PCN AMS-HES/14/8507

Qualification of Crolles Fabrication plant as second source

Analog, MEMS and Sensor Group
Additional capacity for HCMOS5 and HCMOS6
(STLED316SMTR)

Generic ST Standard label

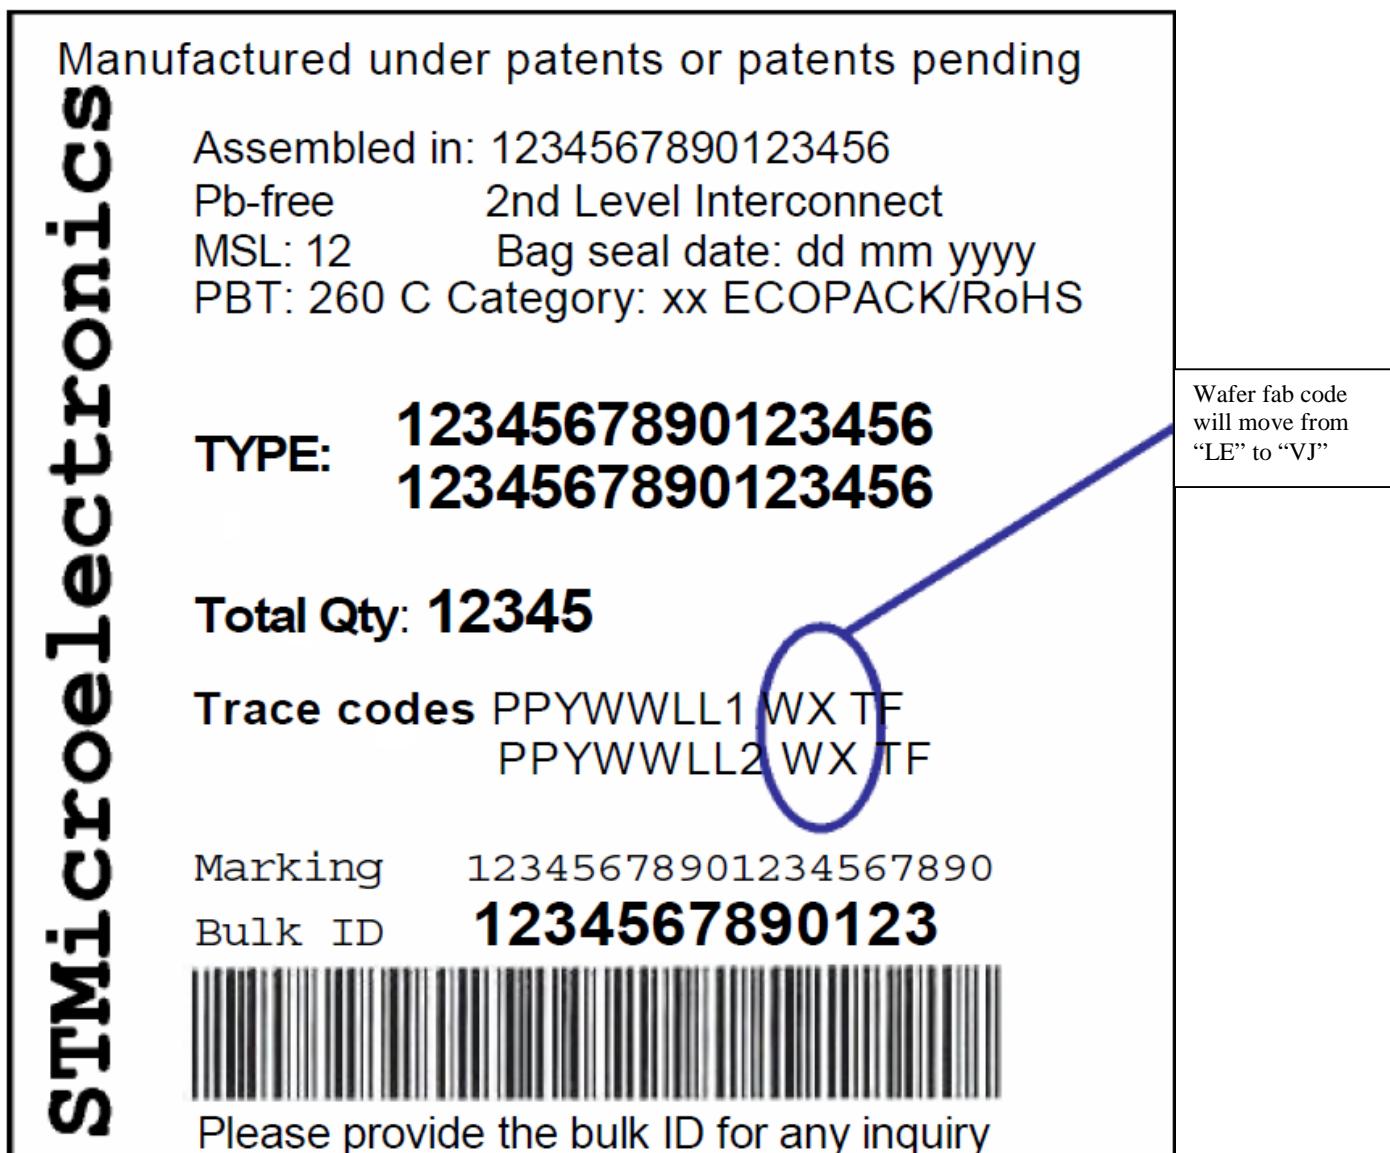
Shipments from new Wafer FAB location will be tracked on the ST Standard Label as showed below:
